# Remedy for PSE SD variable 'power\_available' comments

**Andy Gardner**

# Presentation Objectives

Table 104-2 - PSE power\_available matrix

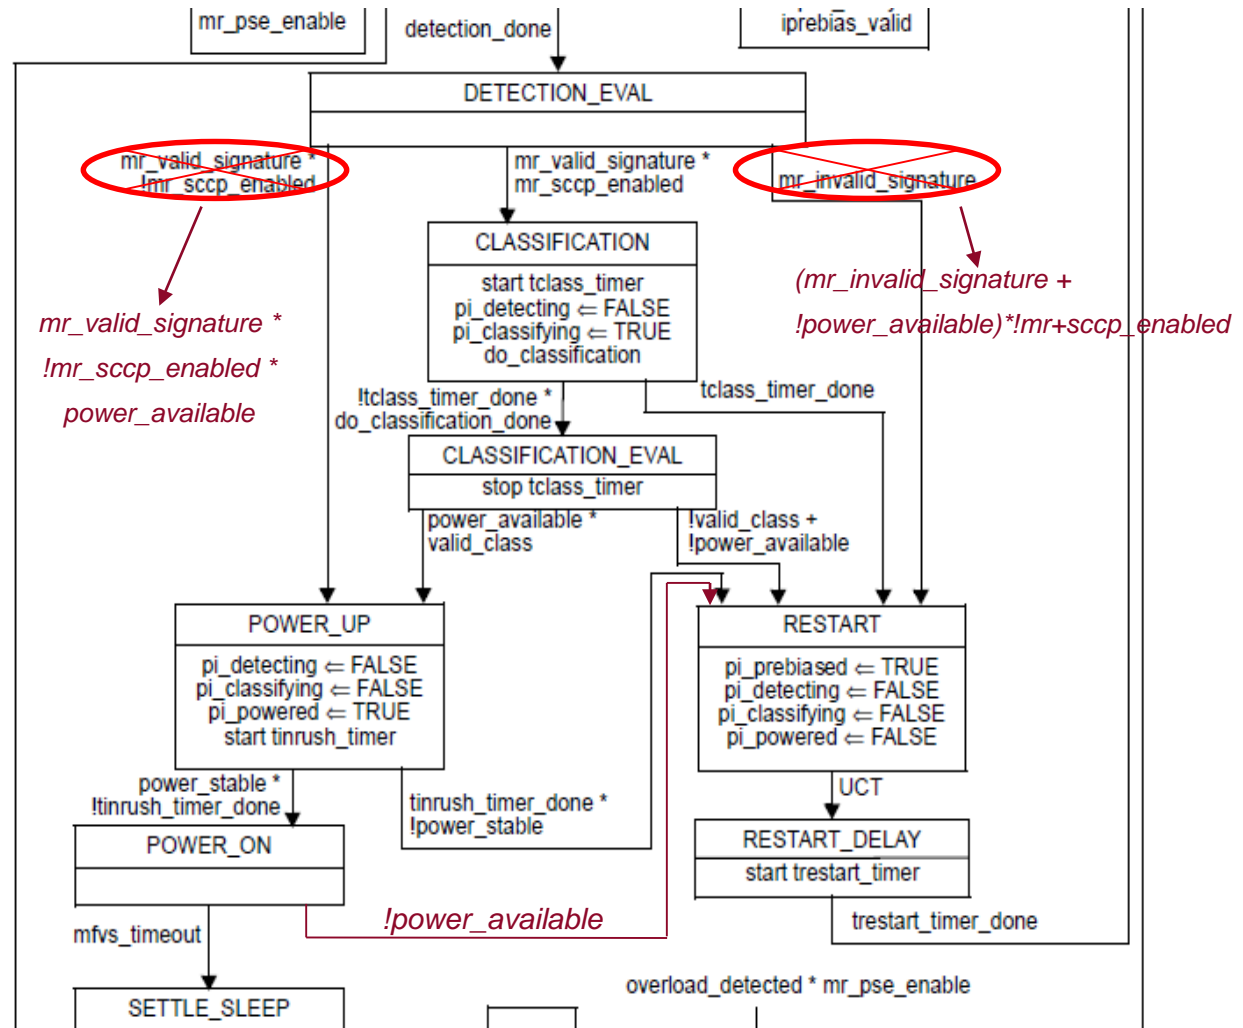
*Editor’s instruction: Replace the definition of power\_available in sub-clause 104.4.3.3 with the following:*

power\_available :

**TRUE:** A compatible PSE class to PD class pairing exists as defined in Table 104-2 and the PSE is able to source the required voltage and power.

**FALSE:** A valid PSE class to PD class pairing does not exist as defined in Table 104-2 or the PSE is not able to source the required voltage and power.

Note - An X indicates a PSE-PD pairing where power\_available is TRUE.
